**MUNICIPAL PLANNING COMMISSION
REGULAR SESSION AGENDA
February 25, 2026, 6:00 pm
Red Bank Court Room
3117 Dayton Boulevard**

Planning Commission Regular Session 2-25-2026

Request: Design review of 546 Morrison Springs Road, “Midgate Commons”

Applicant: River Street Architecture, Chattanooga Exteriors

Rezoning Request

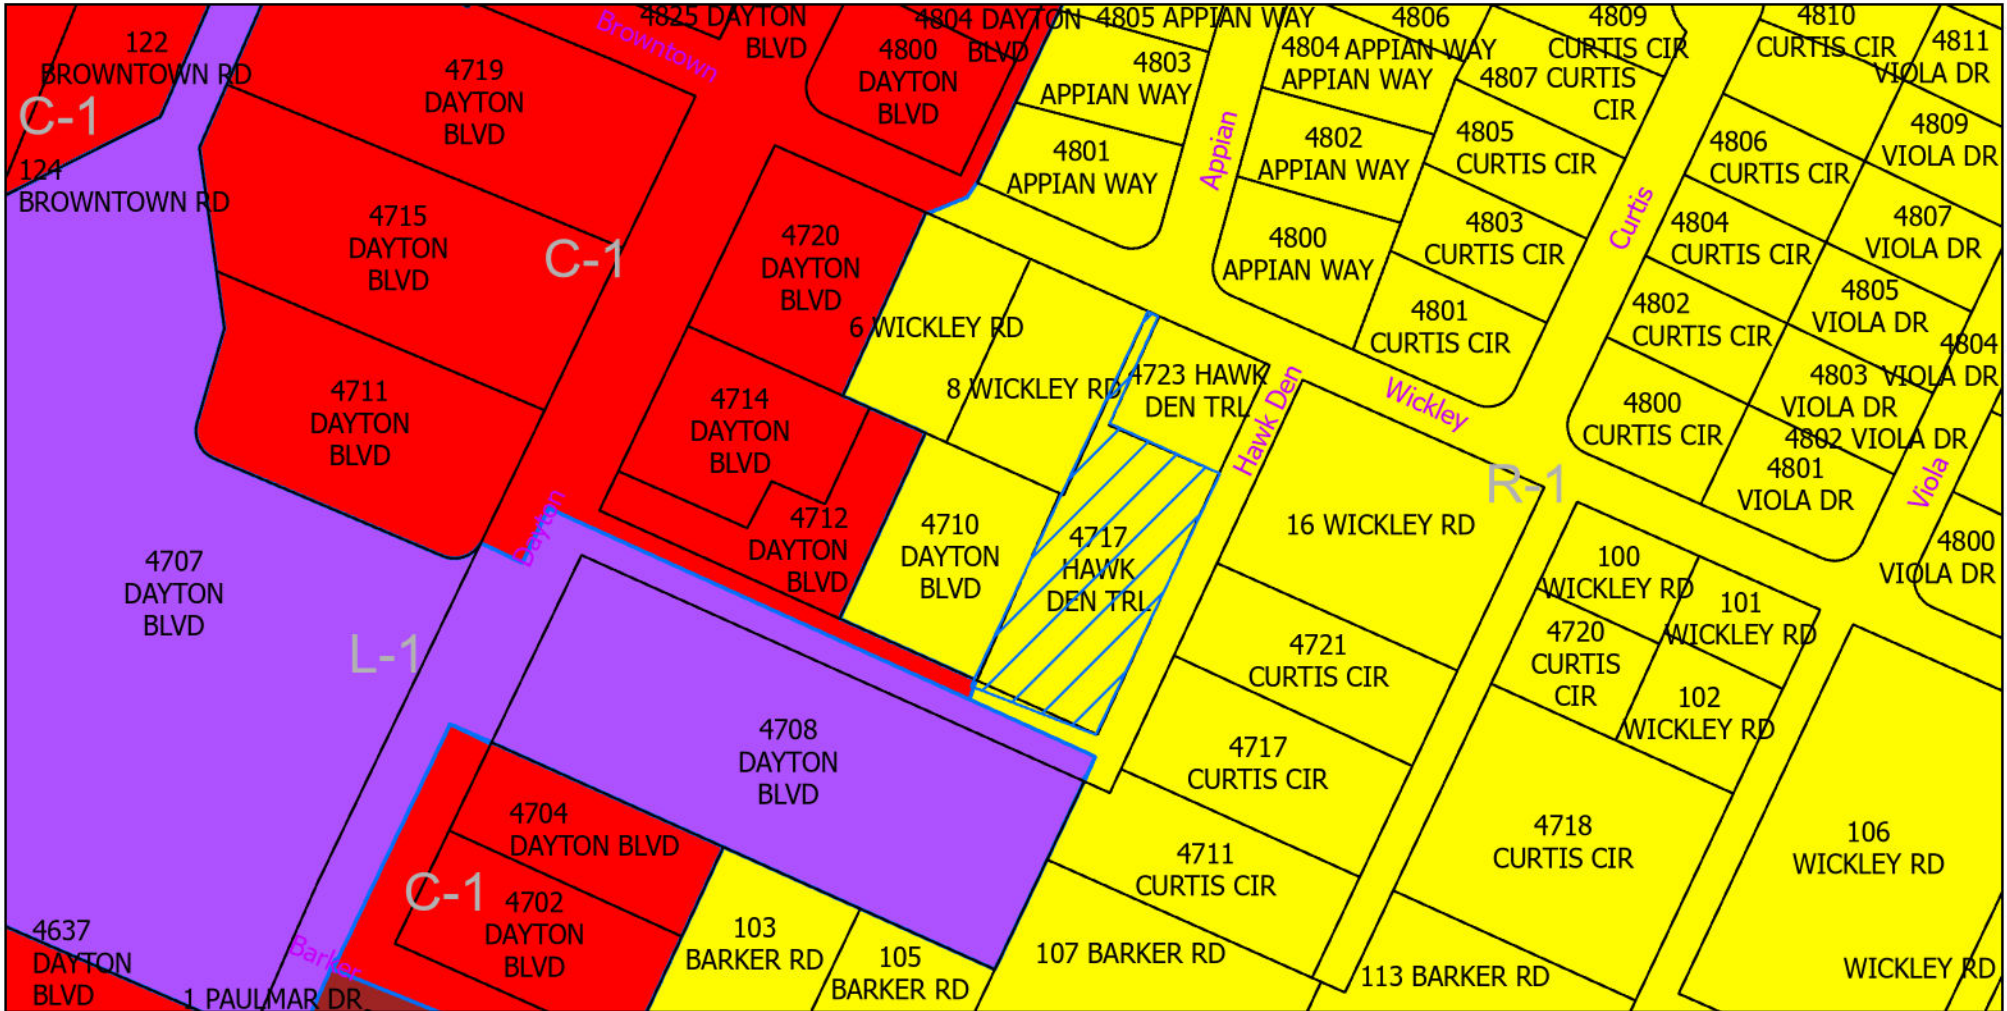
The C-1 commercial zone permits the following uses: banks, barber/beauty shops, studios, restaurants and other establishments serving food and beverages, theaters, shoe repair, retail sales and service establishments, florists, schools, churches and other public and semi-public buildings, plumbing, workshops, electrical, radio and tv shops and other similar uses provided that not more than five (5) persons are employed therein, hotels/motels, short term residential units, subject to certification and issuance and maintenance of current short term residential rental permit, outdoor display or storage or sale of merchandise, signs advertising goods and services, bakeries whose products are sold at retail and on the premises, office buildings, small printer shops, mixed use commercial/residential, accessory buildings, single-family detached dwellings, micro-breweries and/or brew pubs. Permitted by special exception: laundry establishments, miniature golf courses and similar outdoor amusement facilities, bowling alleys or other indoor amusement, halfway house, alcohol and drug rehabilitation centers, veterinarians offices, funeral homes, car washes, hospitals and clinics and social agencies, assisted living facilities, nursing homes, apartments, alternative financial services.

The nearby L-1 properties are currently in use as thrift store, storage facility, retail store. The nearby C-1 properties are in use as an excavation contractor’s office, an automotive shop, a gas station, an aluminum supplier. A rezoning to C-1 would require Type B screening which is a 20’ deep landscape buffer of evergreen trees or shrubs against any R-1 zone.

The comprehensive plan designates the property as “valley residential” which is predominantly single-family. Policy recommendations are to accommodate housing types such as townhomes, duplexes, triplexes, and quadplexes, with the opportunity for ADU. The other nearby placetype is “north end” which recommends development of out parcels along Dayton Boulevard, improved pedestrian connections to nearby neighborhoods, reduced amount of surface parking and improved public space, and beautification efforts.

A C-1 rezoning request does not require a site plan, however, adherence to the zoning code development standards and screening requirements would be enforced when applying for building permits.

Staff Recommendation: Approve

Because of the nearby parcels being zoned C-1 and L-1, the rezoning would not be considered spot zoning. While the lot in question is designated as “valley residential”, which does not specify commercial development, there is the possibility of connecting this public right-of-way to Wickley Road and Dayton Boulevard as an enhanced pedestrian access point alongside the development of a commercial use on the lot. An argument can be made that the lot having close proximity to the commercial corridor and residential neighborhoods can have a positive impact on the community through the various commercial uses that are permitted in the C-1 zone.
